Ad Hoc Committee Agenda Item #:	III.A.—Action Item
Date:	June 3, 2019
To:	Magnolia Educational & Research Foundation dba Magnolia Public Schools (“ <b>MPS</b> ”) Ad Hoc Committee (the “ <b>Committee</b> ”)
From:	Alfredo Rubalcava, CEO & Superintendent
Staff Lead:	Patrick Ontiveros, General Counsel & Director of Facilities
RE:	MSA-1 Change Order Requests 6 and 7

Staff recommends and moves that the Ad Hoc Committee approve change orders 6 and 7 presented by Oltmans Construction Co. (“**Oltmans**”) for the new construction project for the benefit of MSA-1 at 18220 Sherman Way (the “**Project**”).

Change order no. 7 consists of CORs/PCIs 28, 29, 31, 32, ~~33~~, and 34 **and 35 and the total cost is \$33,864.94**. Each COR/PCI is explained below. Change order no. 7 with all associated CORs/PCIs is attached as Exhibit B.

A0.5A

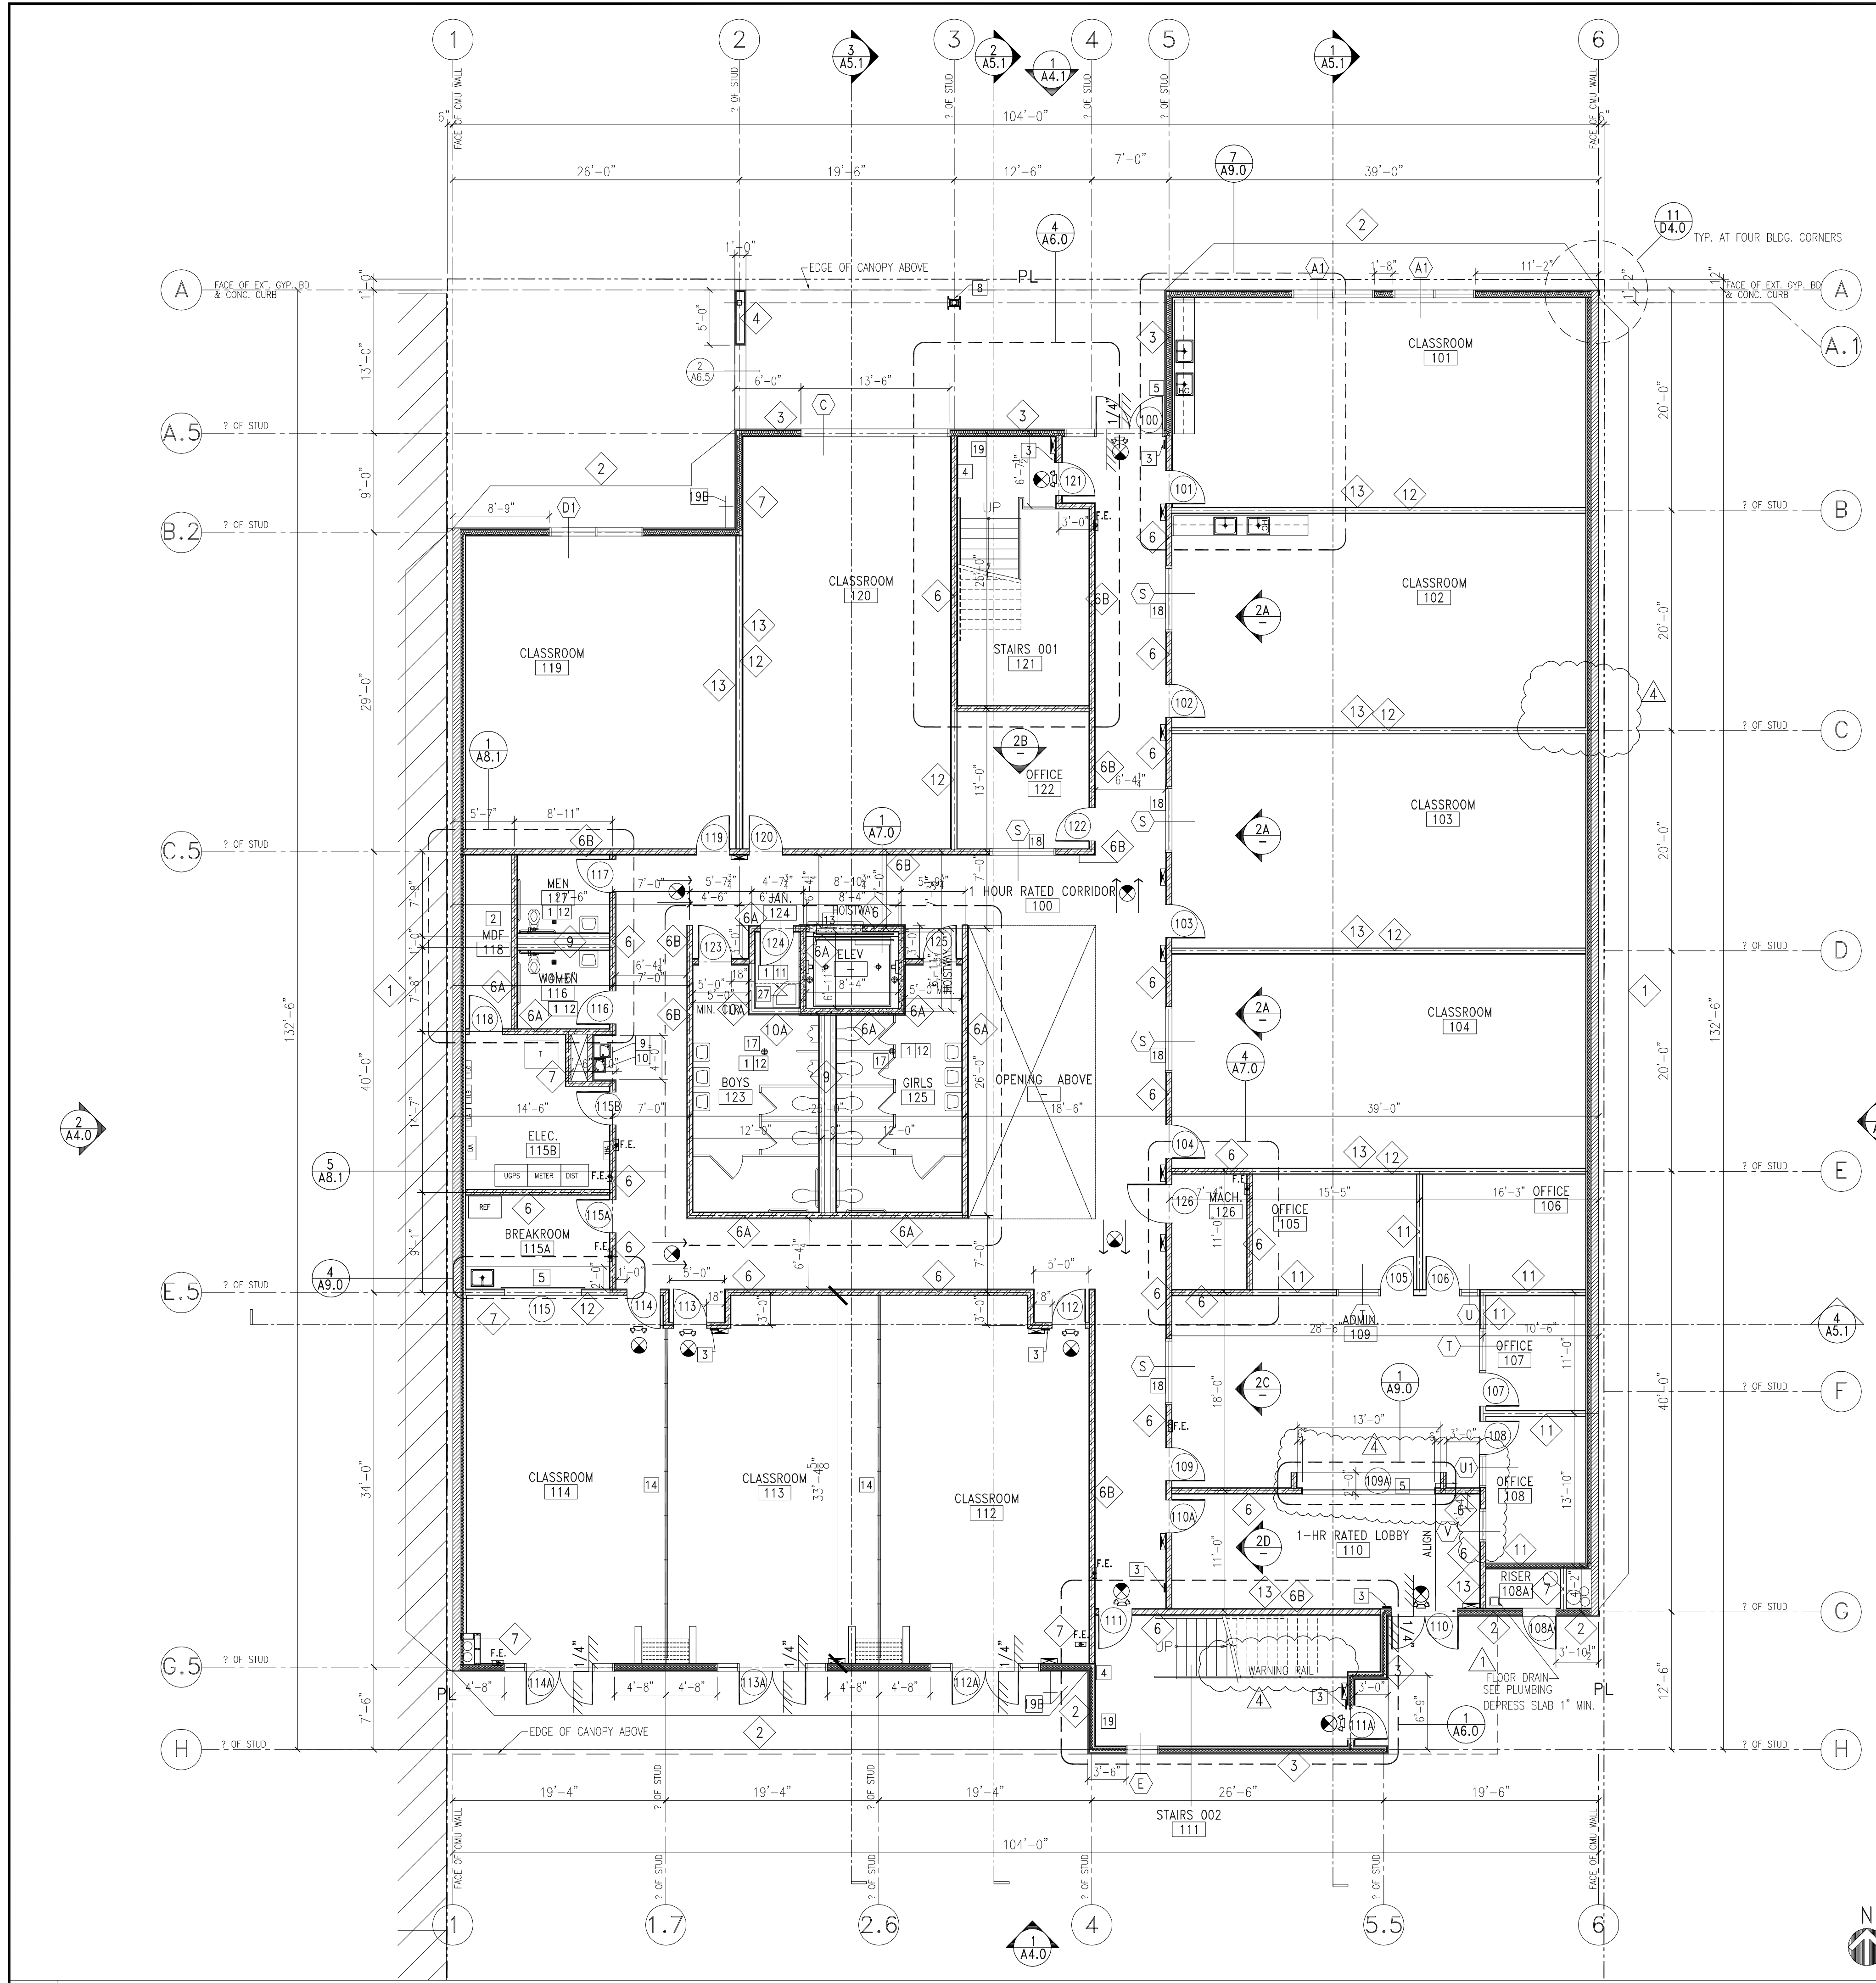
- RE: RF1-071
- INCLUDES:
- PERMEABLE CONCRETE AT NORTH PORCH
  - REMOVE 2 LIGHT POLE AND MOUNT SITE FLOOD LIGHTS ON THE BUILDING ELEVATIONS
  - ADD SITE SLOPE AT THE OUTDOOR AREA SOUTH OF THE BUILDING - SHOWN IN 3 SECTIONS.
  - REMOVE THE WEST FENCE.
  - SHOW TRENCH DRAIN PER CIVIL DESIGN.
  - USE MANUAL SLIDING GATE AT THE ALLEY.

**1 FIRST FLOOR CONSTRUCTION PLAN**  
SCALE: 1/8" = 1'-0"

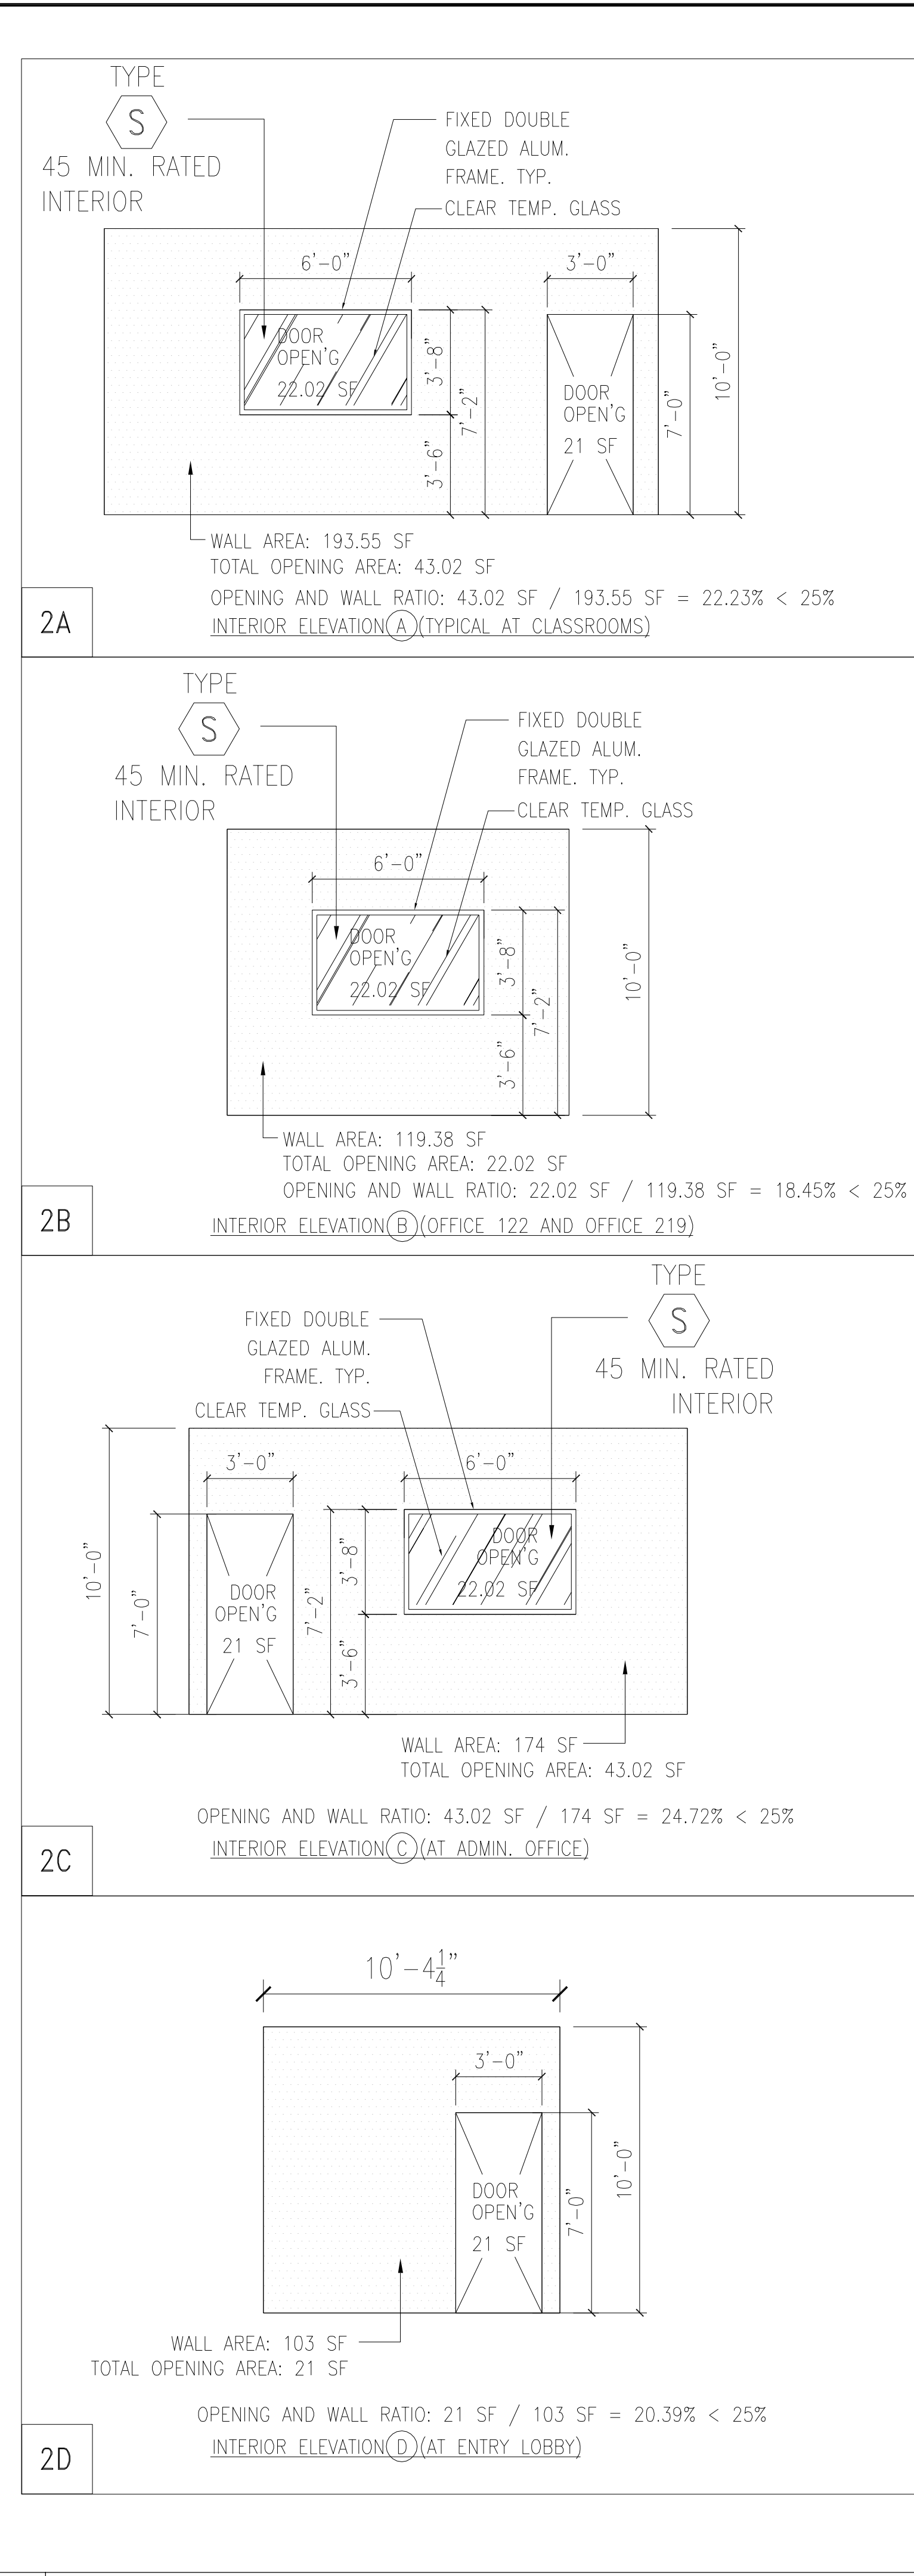
- SEE A2.1 FOR GENERAL NOTES
- CHANGES:  
ENTRY INTERIOR WINDOWS  
STAIR-002 REPLACE WALL WITH RAIL  
REMOVE SHAFT AT LINE G & C
